CPED STAFF REPORT

Prepared for the Heritage Preservation Commission

HPC Agenda Item #2
August 19, 2014
BZH-28278

Property Location: 428 2nd Street South
 Project Name: Mill City Quarter Phase 2
 Prepared By: [Janelle Widmeier](#), Senior City Planner, (612) 673-3156
 Applicant: Ecumen
 Project Contact: Charlene Roise, Hess, Roise and Company
 Ward: 3
 Neighborhood: Downtown Minneapolis Neighborhood Association
 Request: To allow a new 5-story assisted living facility.
 Required Applications:

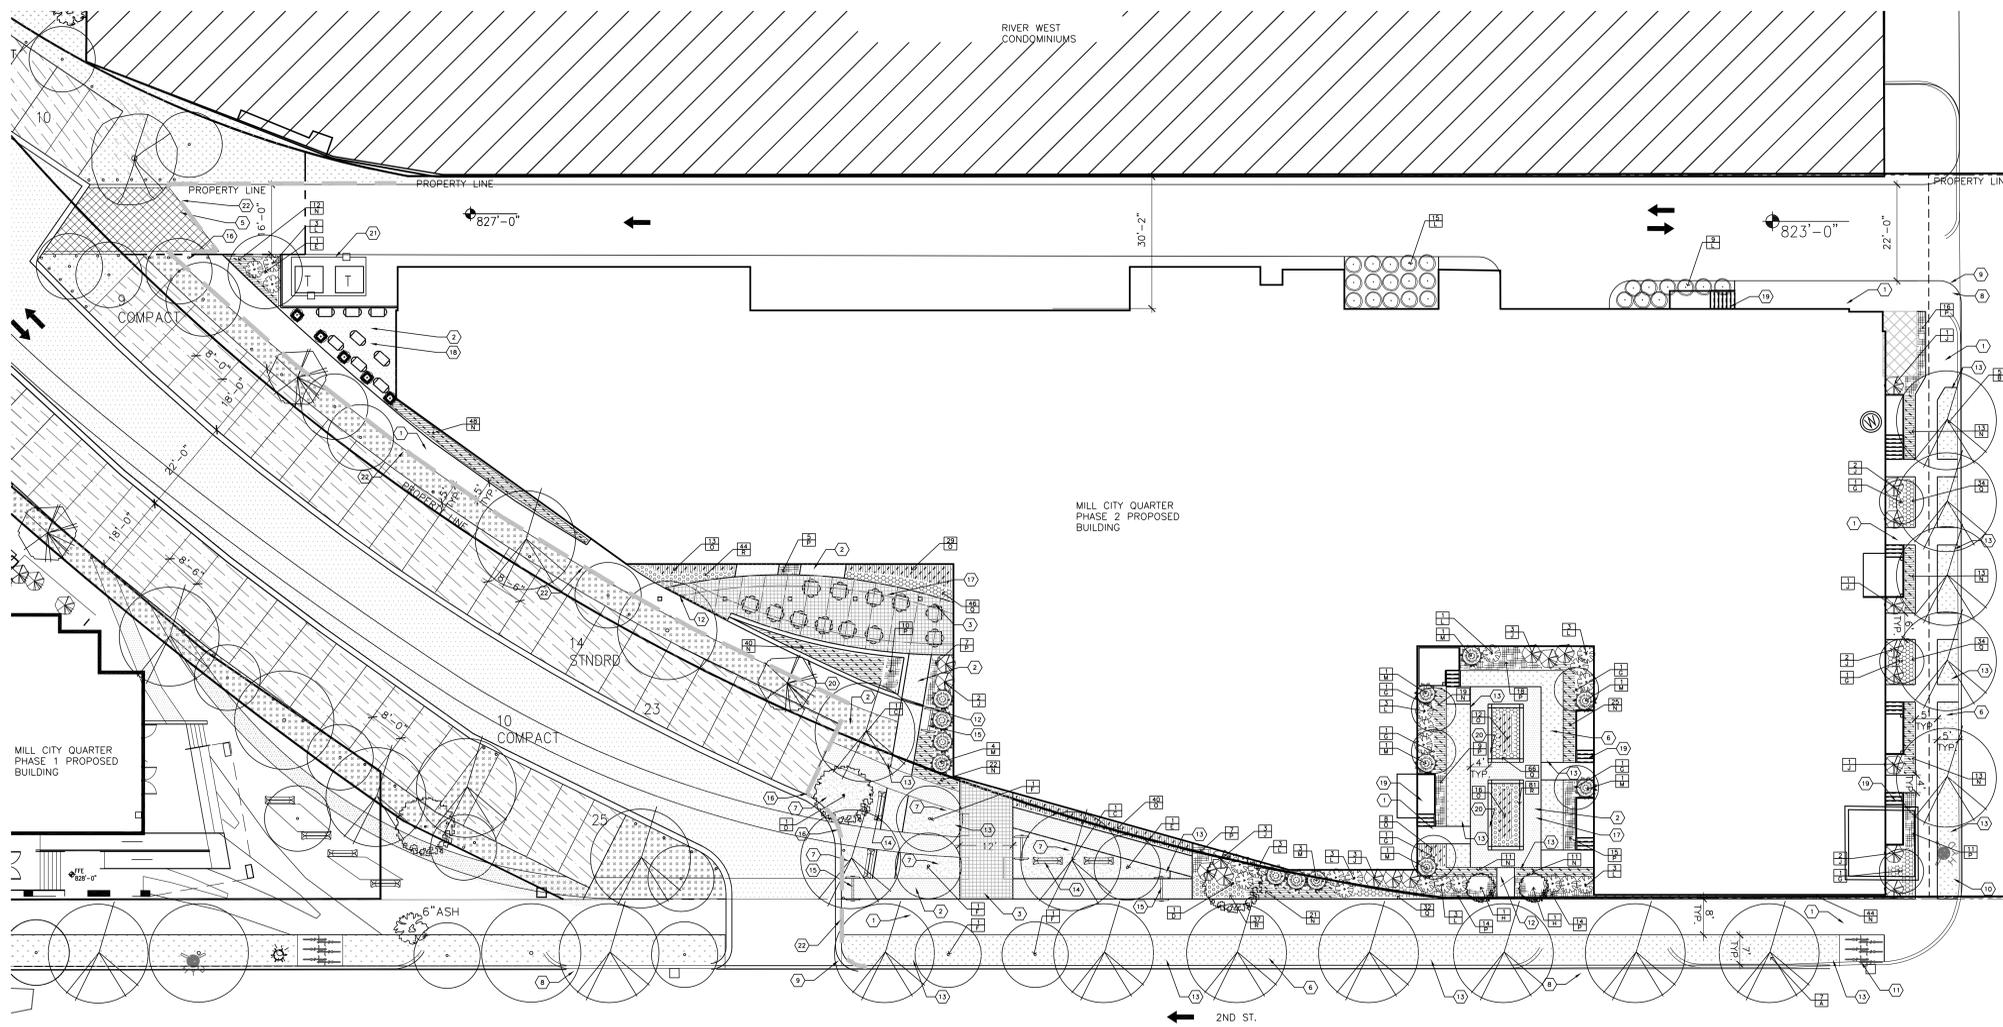
Staff comment: Fairly regular spacing of the boulevard trees is proposed, with the exception of the trees next to the main entrance. Staff is recommending that the HPC require the applicant to modify the tree planting locations in the boulevards to be clustered and spaced more irregularly.

3. The tree planting locations in the boulevards shall be modified to be clustered and spaced more irregularly to evoke a sense of the volunteer nature of vegetation in an industrial setting.

1
A401
3/32" = 1'-0"
Rendered - South Elevation

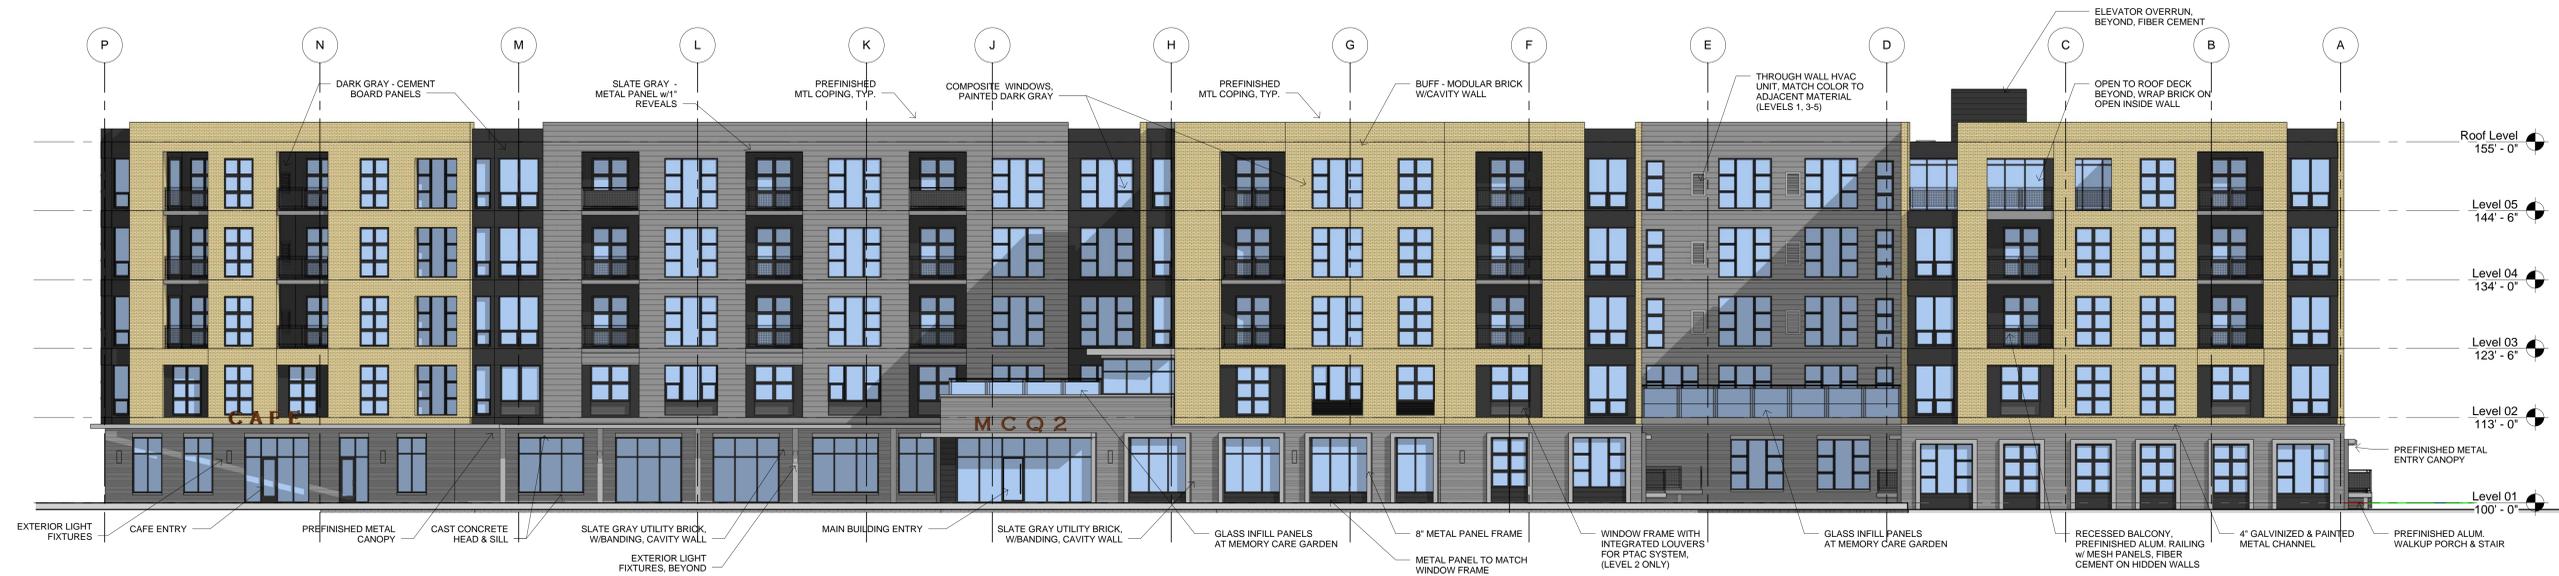
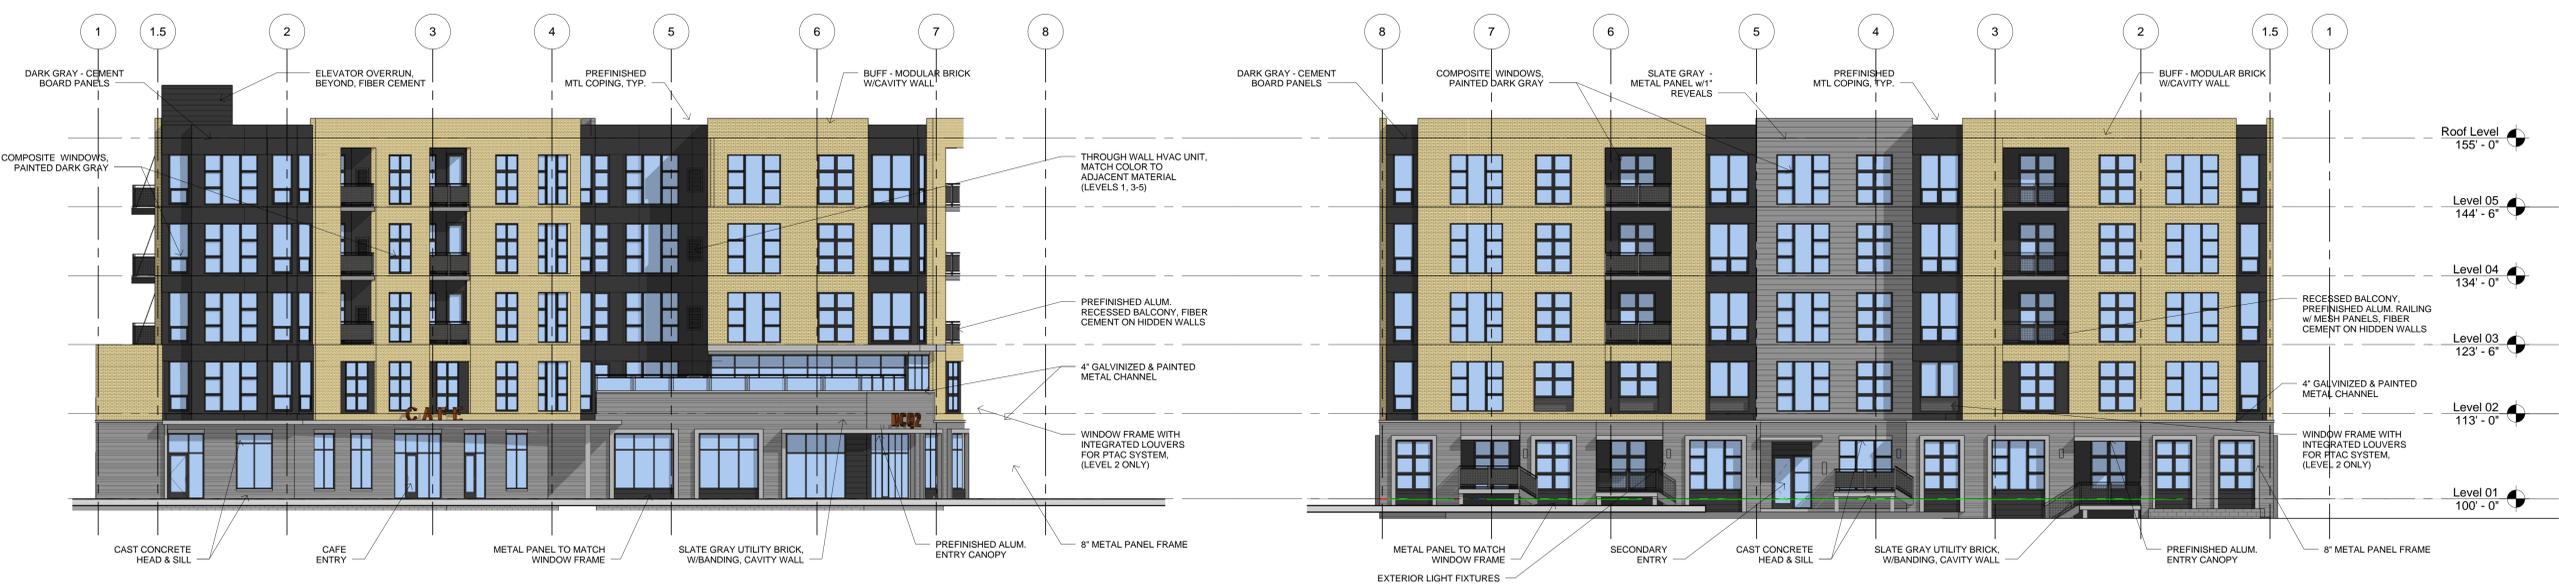
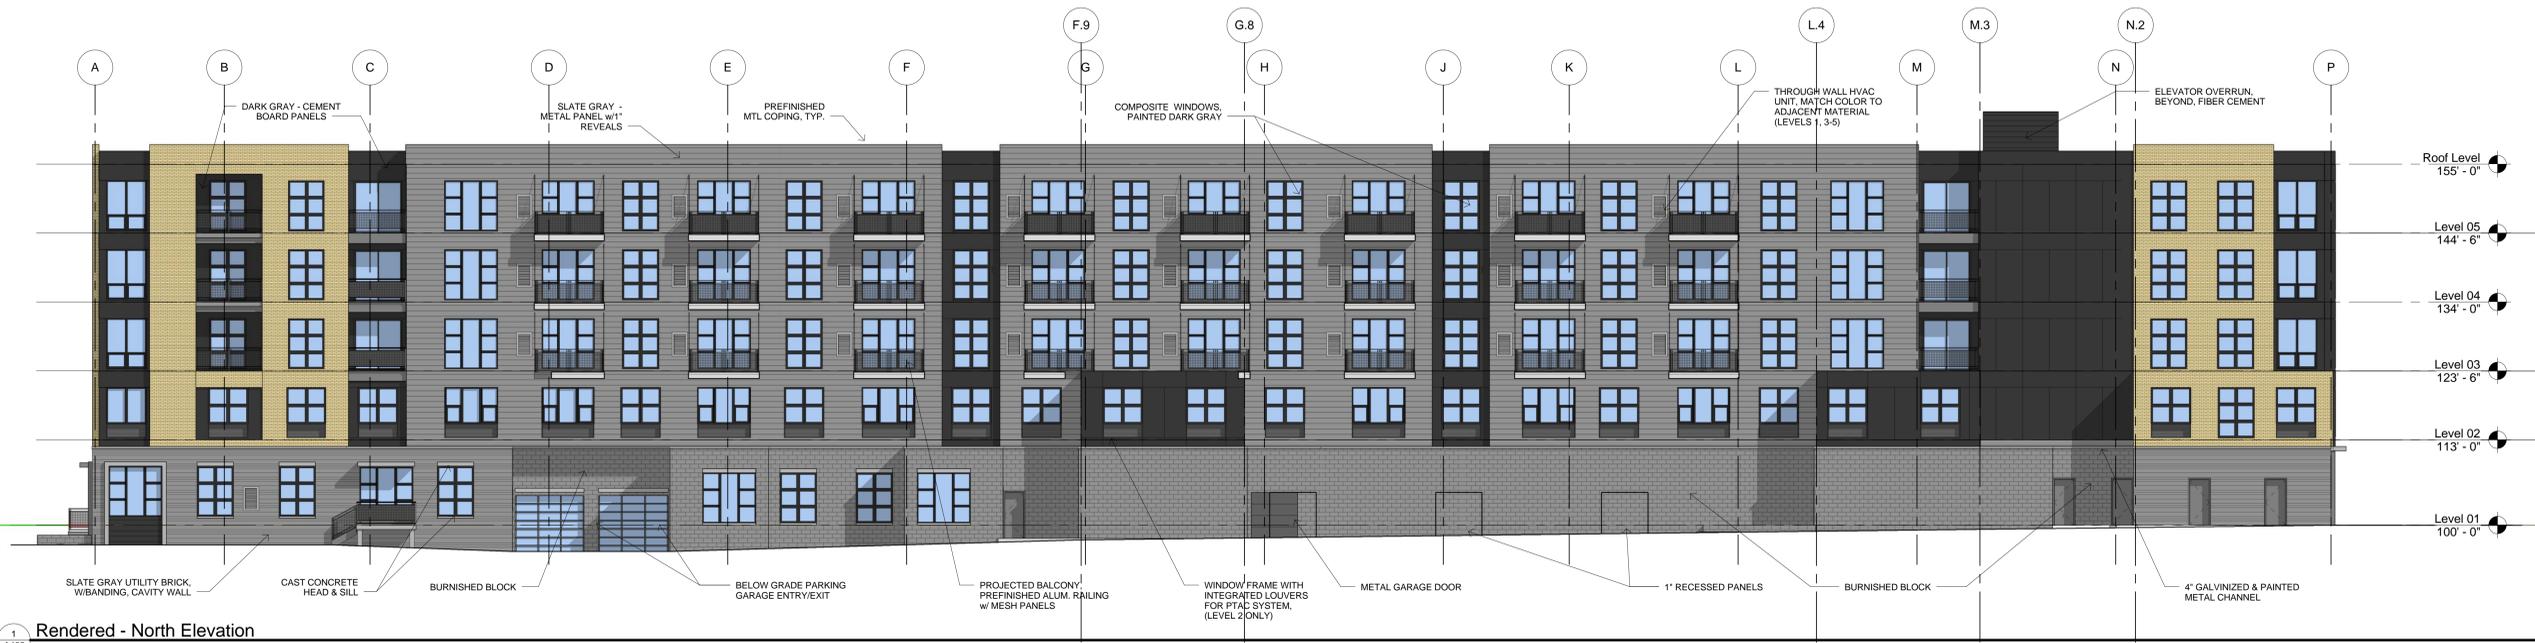
Staff comment: A slate gray utility brick is proposed on the base of the building. The dimensions of utility brick (approximately 3.5 inches x 3.5 inches x 11.5 inches) are larger than the modular brick (approximately 2.25 inches x 3.5 inches x 7.5 inches) and smaller than the stone masonry typically found in the district. The burnished block proposed on the north elevation is more typical in size compared to the stone masonry. However, wrapping the entire ground level in burnished block would not be appropriate in the district or a desired aesthetic. The applicant has indicated that the color and size were chosen to reinforce a strong base. The concept is consistent with historic buildings with exposed foundations in the immediate area.

Staff comment: Four to five primary exterior materials, not including glazing, are proposed on each building elevation. Brick, followed by glazing, would be the dominant materials on the east, west and south elevations, which are considered the primary elevations. The composition of the materials helps to create smaller building modules on a block long building. Extensive embellishments have been avoided to simplify the design. Although the use of fiber cement is generally discouraged, it is minimally used on each building elevation and less so than was approved for the Phase I development at 300 2nd Street South.

Staff comment: The east, south and west elevations are considered primary facades. Penetrations for the HVAC equipment would be located on the balconies facing inward, except for the second floor memory care units and on the south wall in the private courtyard. The south wall of the courtyard is set back 76 feet from the street. The memory care units will be

Site Plan Review is required for the proposed development. The proposal appears to comply with most of the site plan review standards. However, there appears to be walls without sufficient architectural elements on the ground floor of the north elevation. Remedying these deficiencies should only require minor alterations.

- Design Response to HPC Comments: The base has been reduced to a single brick color/type on the primary facades. The design still features masonry sills, and bases have been added to further define the windows within the base.
